RECODE KNOXVILLE

Charrette Report

The East Tennessee Community Design Center appreciates the opportunity to develop this report on the findings from the Recode Knoxville Design Charrette and Design Standards Roundtable Discussion.

Burlington

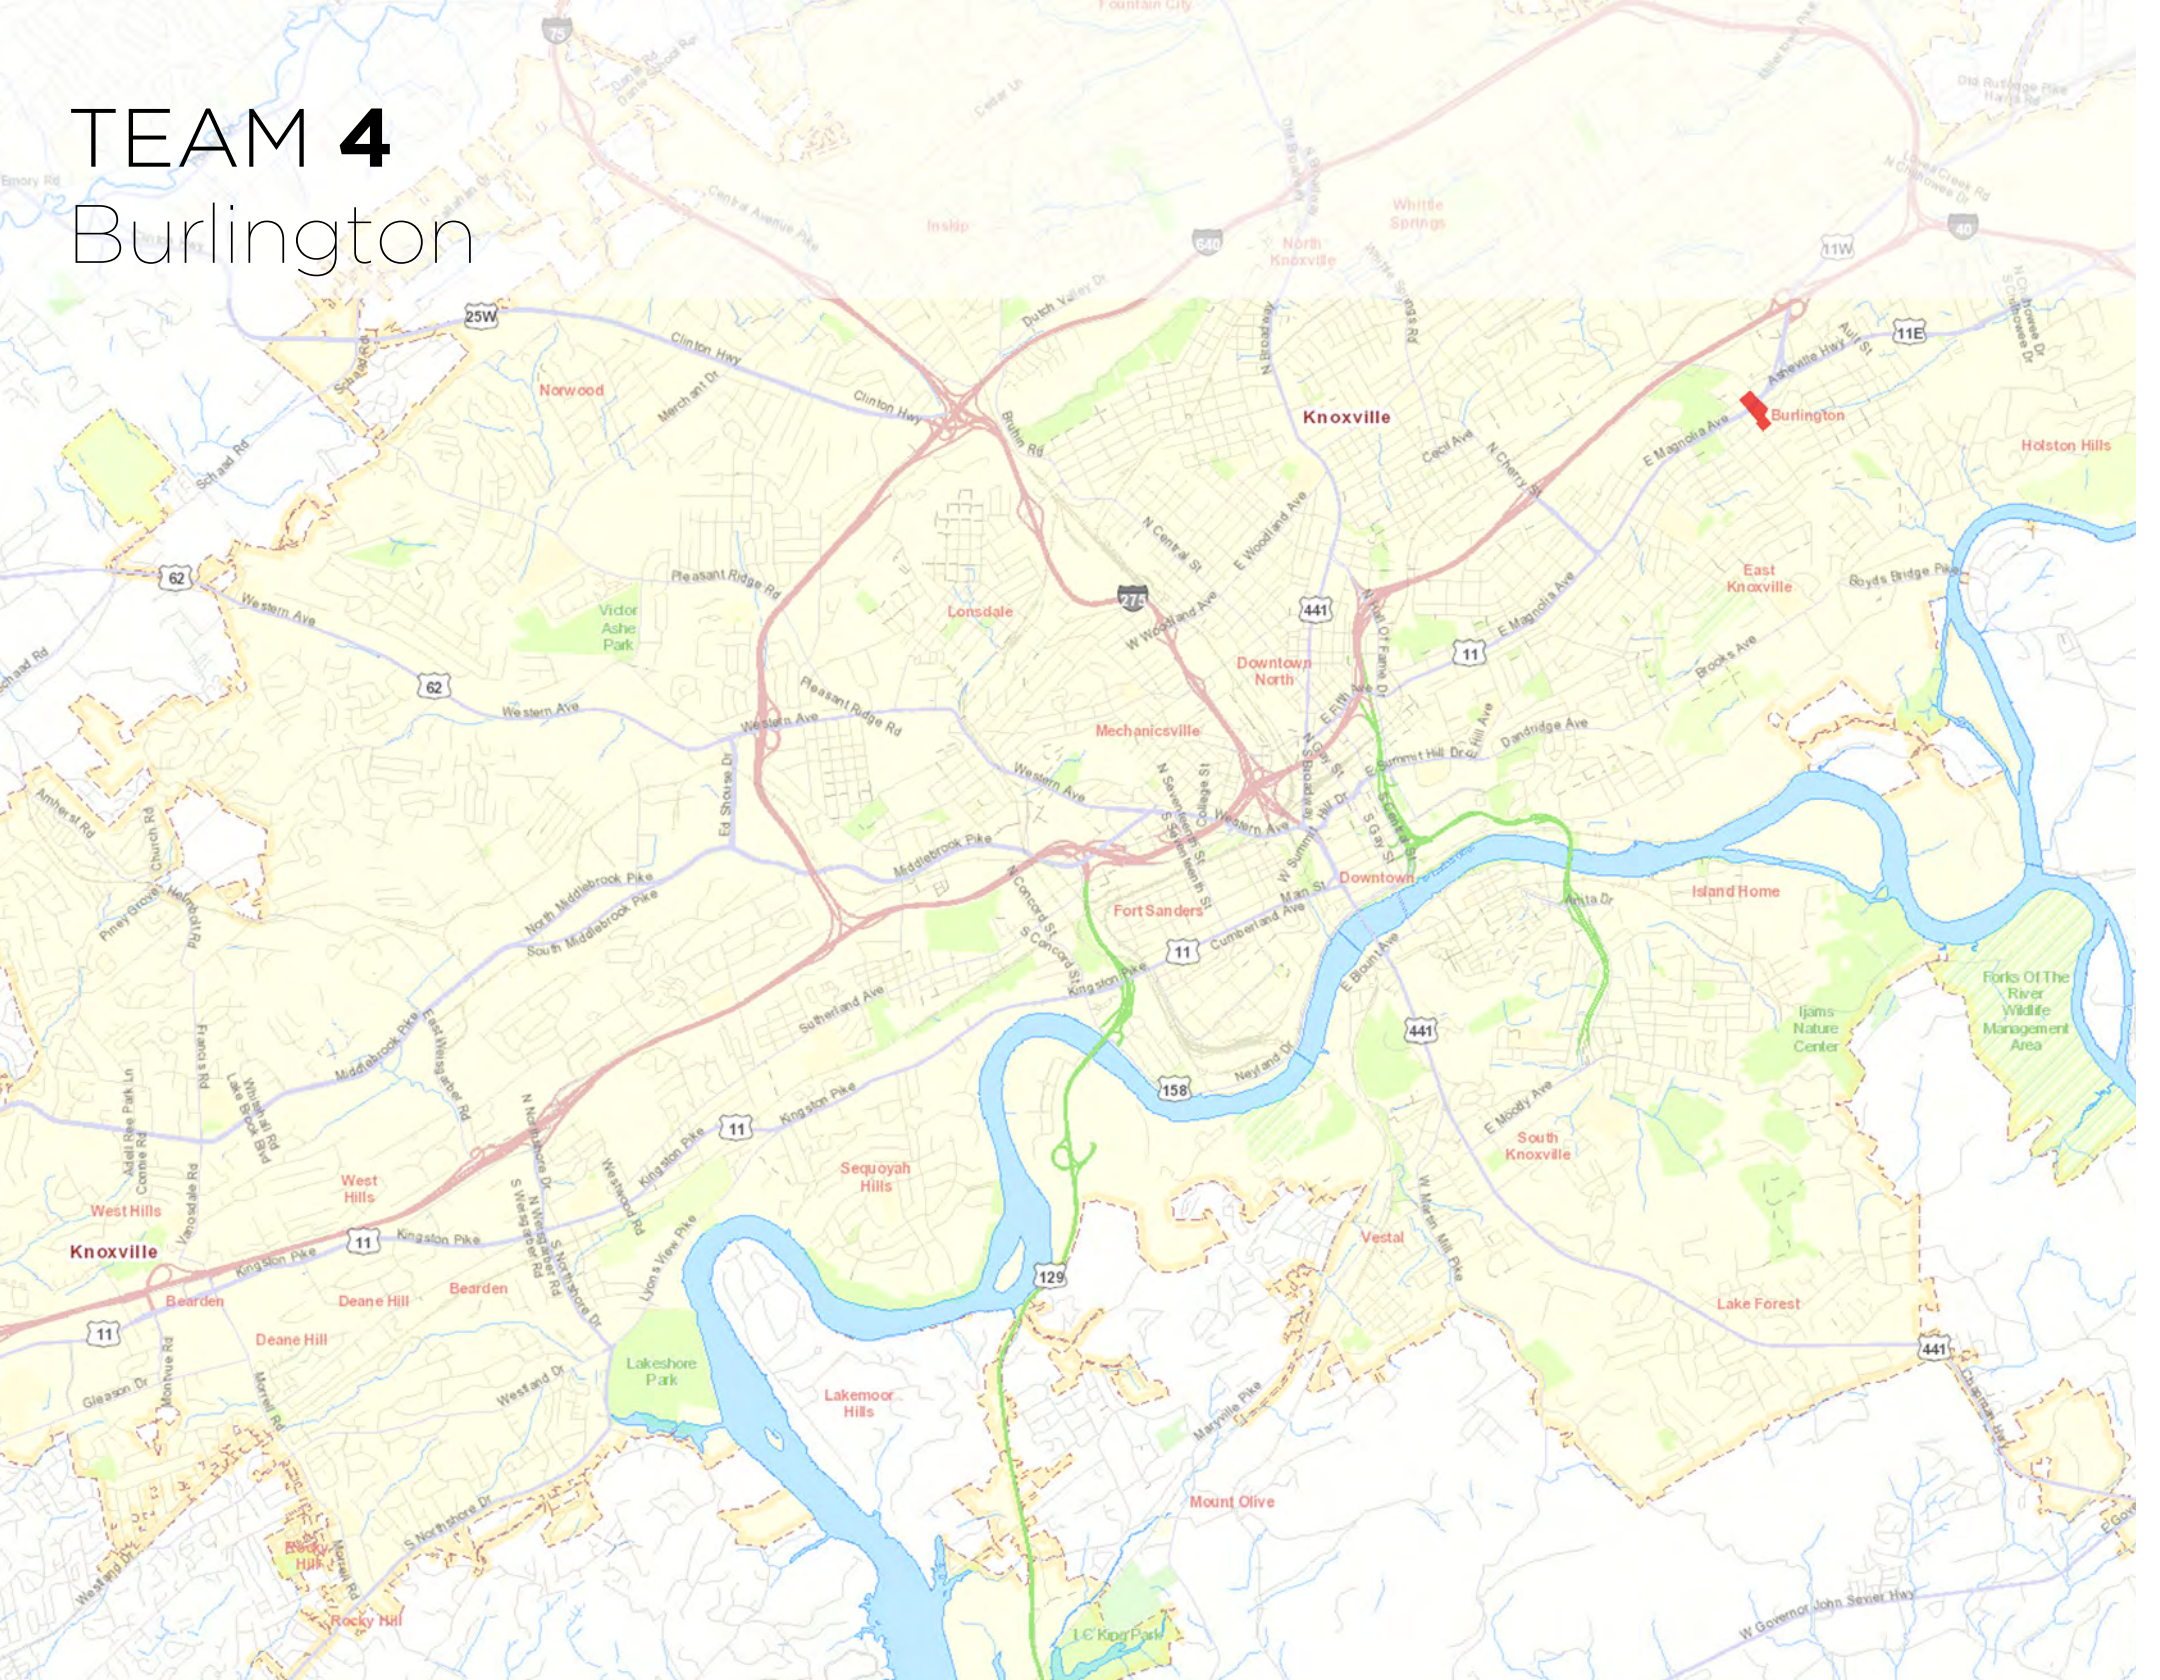
Team 4 found that, similar to the Bearden site, their site in Burlington naturally lent to an easy transition of low density zones on the edges to more intense developments in the commercial core. On the northern and southern ends of the site, single family housing was either retained or created. On the northern side of Magnolia, medium-sized office buildings were created to front the street, with the RN-4 zoning behind them allowing for the creation of new town homes. On the southern end of the site, the two existing churches were kept, though the question was raised as to why one was zoned Residential and another Office, and how that would affect the future uses of the buildings, should the congregations ever move or dissolve.

The middle block, in between Magnolia and Martin Luther King, Jr. Avenues, was developed in a way that removed the overly large, existing curved road and replaced it with a landscaped parking lot for two twin four-story mixed-use buildings that front both of the corridors.

- There is a need for more organized on-street parking in certain parts of the city such as this site, and it is perhaps worth looking into creating a shared parking scenario with nearby on-street parking that could reduce the off-street requirements.
- For smaller historic commercial strips such as Burlington, a change of adjacent zones from General Commercial (C-G) to Neighborhood Commercial (C-N) seems to be more appropriate in regards to the allowed uses within those zones

Chapman Highway at Moody Avenue

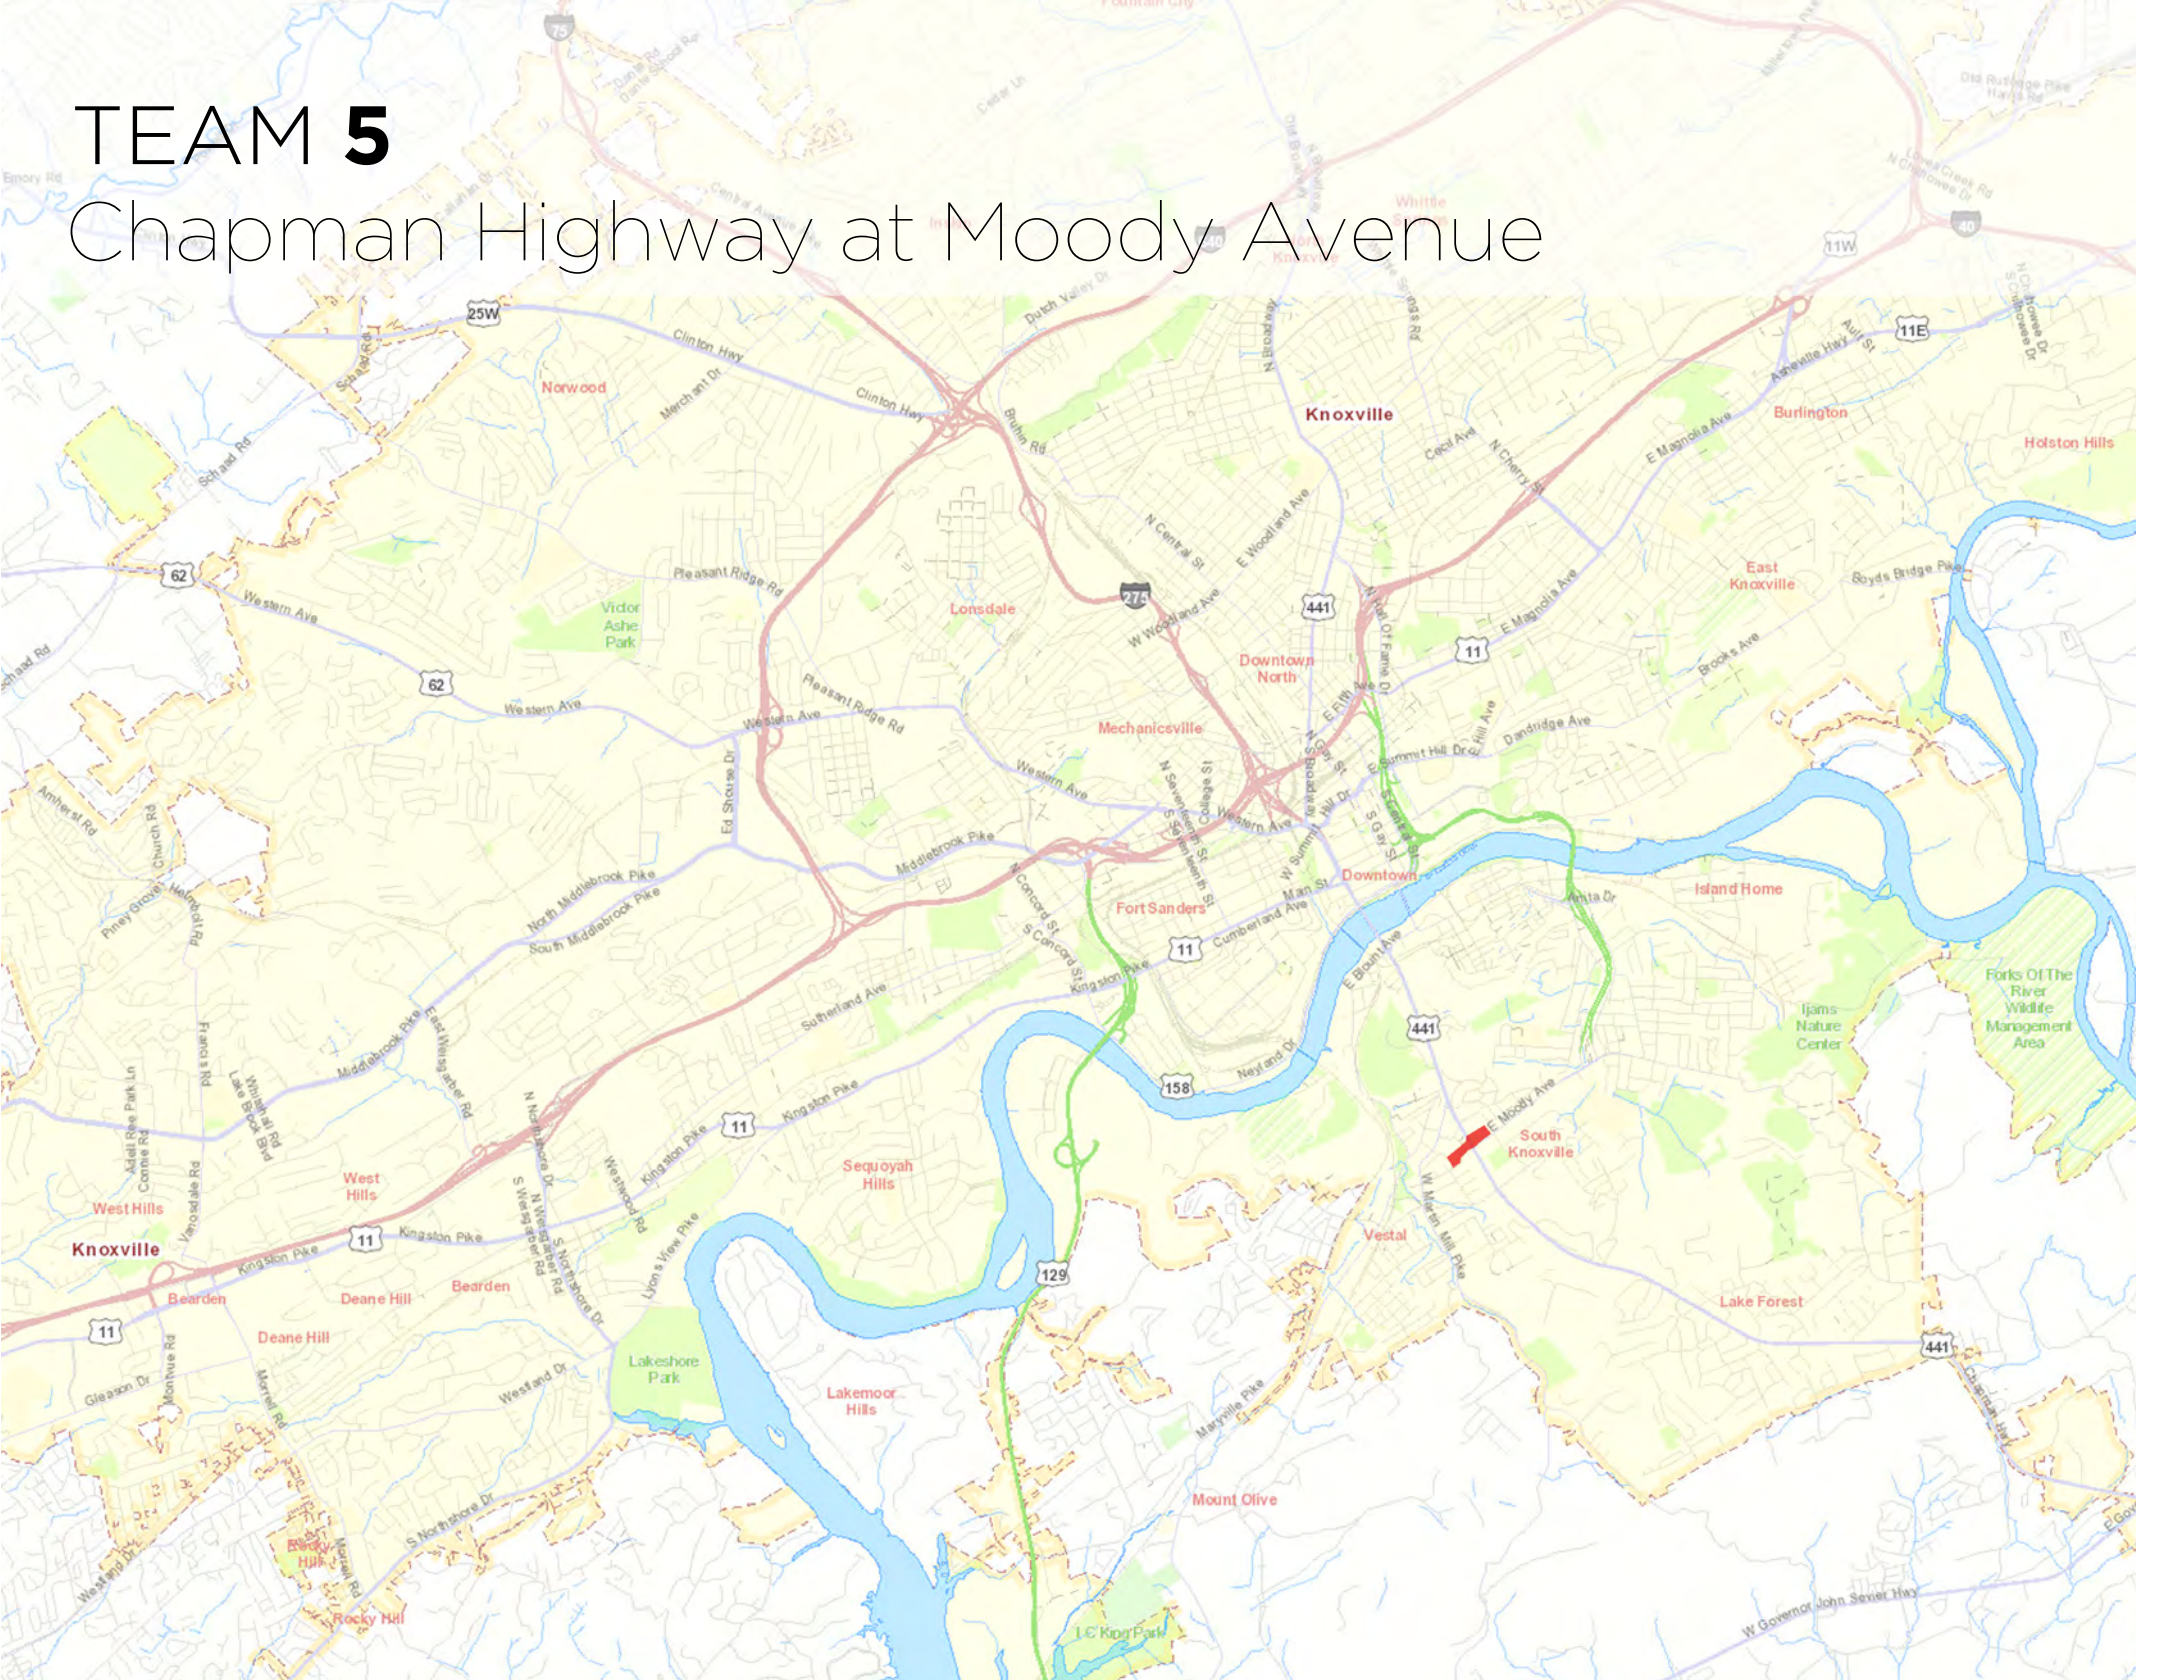
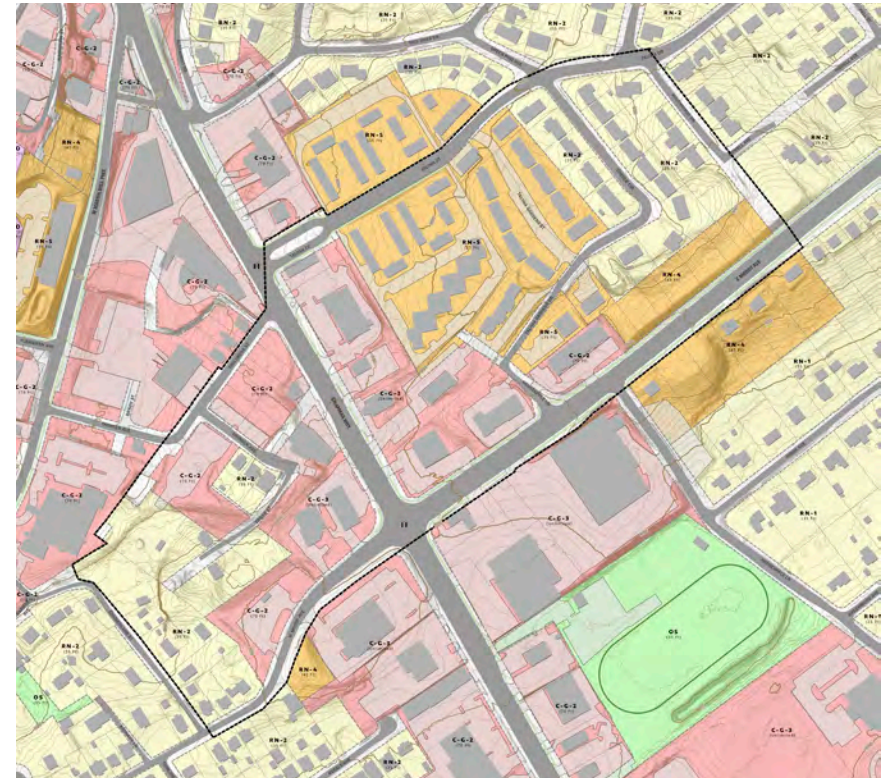
Team 5 found that the unique topography of their site created a necessity for open spaces and green buffers that the code was unable to account for and that the map did not address. The western side of the site - where there is a large depression and are a few, somewhat isolated, residential parcels surrounded by commercial zoning - was made into a new park / open space to act as a buffer between the single family neighborhood and the large mixed-use developments up the hill along Chapman Highway. A commercial zone in between these two areas was changed into an RN-4 zone to aid in the zoning transition up the hill.

The team was able to push development of multi-story mixed-use buildings to the street edge of Chapman Highway, but due to the parking requirements and the desire to hide the parking in the center of the block, were also motivated to create large buffers of green space between the lots to break-up the 'sea of asphalt'. They also felt that the landscaping buffer requirements, especially when dealing with commercial zones abutting residential ones, were rather unclear.

The developers expressed concern about the goal of reduced curb-cuts along Chapman Highway and the need to hide parking, stating that they felt it would be harder for visitors not from the area to find parking. They also expressed concern that the more urban development pattern would harm the desire for drive-through restaurants, which are typically their most lucrative businesses.

- The current low-income apartments (zoned RN-5) are the perfect spot for two or three story multi-family housing areas, though it would make more sense for this site to be a gradient of RN-7 down to RN-4 as it got closer to the RN-2 neighborhood on the east of the site.
- The apartment complex was also a good site to test out the new 'pocket neighborhood' design.
- The newly zoned RN-4 along the northern edge of Moody is good in principle, but both the designers and the developers felt that the topography was ignored when changing the zoning, and that due to the topography and parking requirements, building town homes there would be extremely difficult.
